**STATE OF HAWAII
DEPARTMENT OF TRANSPORTATION
AIRPORTS DIVISION**

ADDENDUM NO. 2

**DRAINAGE AND WIND CONE IMPROVEMENTS
AT
HILO INTERNATIONAL AIRPORT
HILO, HAWAII**

STATE PROJECT NO. AH1021-20

C-28

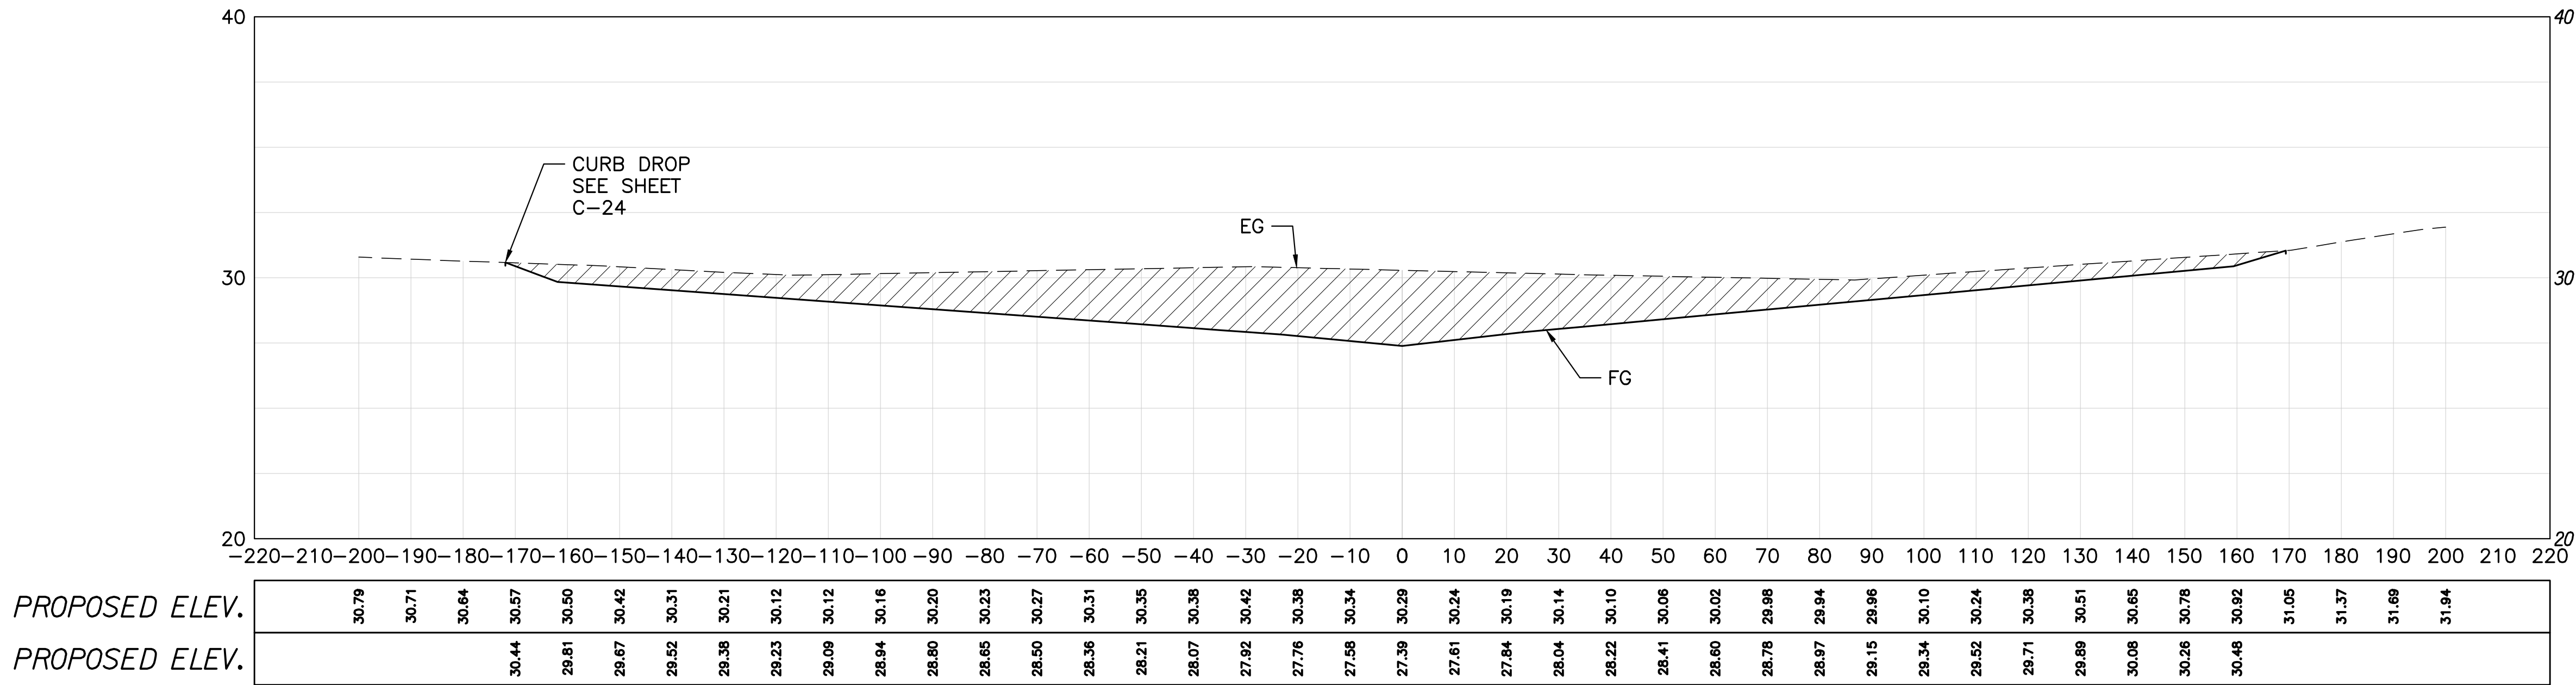
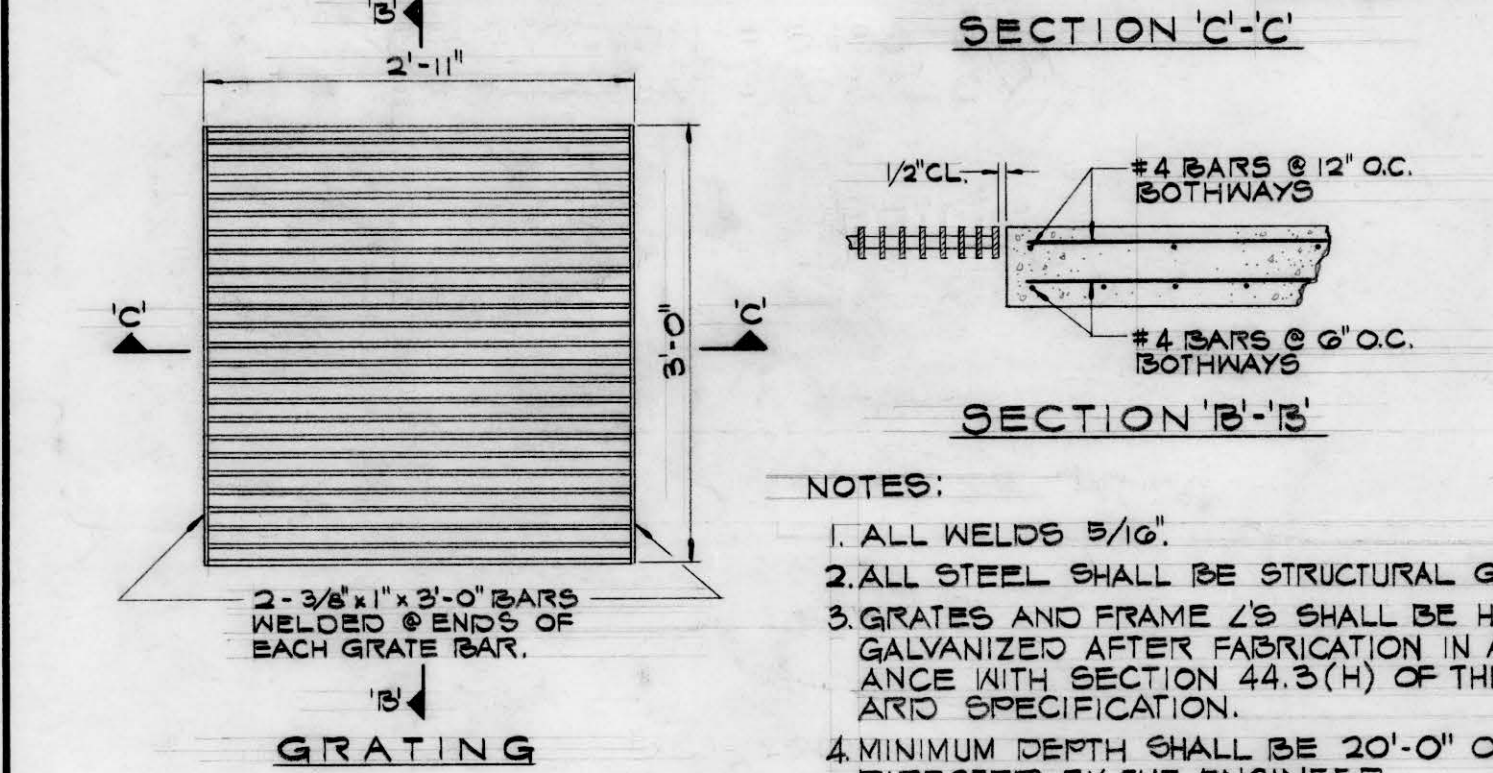
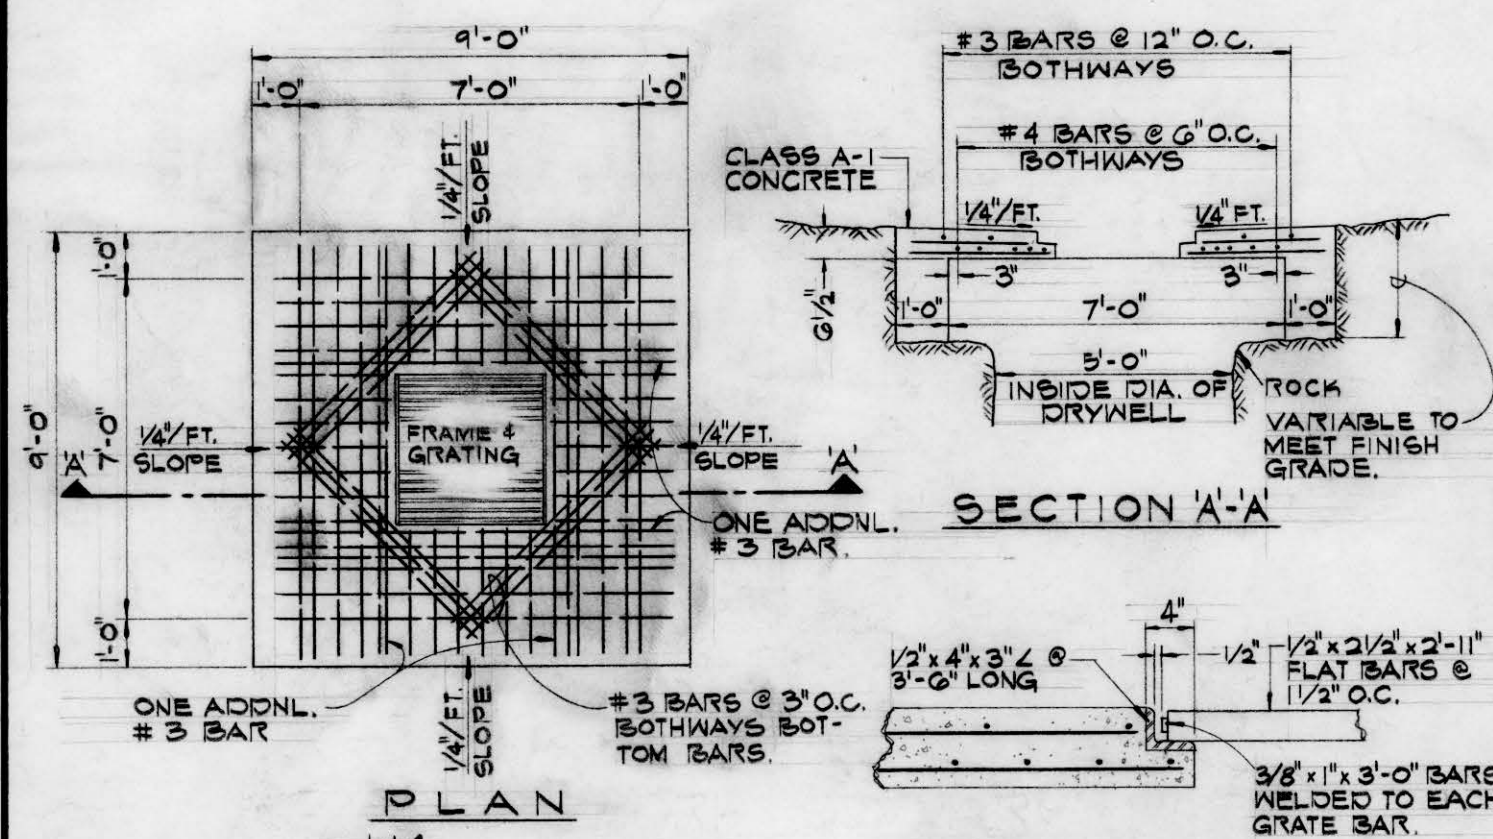
- a. Delete DWG NO. C-28 and replace with the attached Addendum No. 2 DWG NO. C-28 dated 1/9/23.**

- b. **Question:** “Materials at Station 1+50 Table” is missing from the current plan set, could you please provide missing data C-28 x-section 1+50?
Answer: See DWG NO. C-28 dated 1/9/23.

ARMY NATIONAL GUARD AVIATION RAMP GRASS: STA. 1+50.00

Material(s) at Station 1+50.00			
Material Name	Area	Volume	Cumulative Volume
Ground Removed	472.45	804.01	1762.59 CuYd
Ground Fill	0.00	0.00	0.00 CuYd
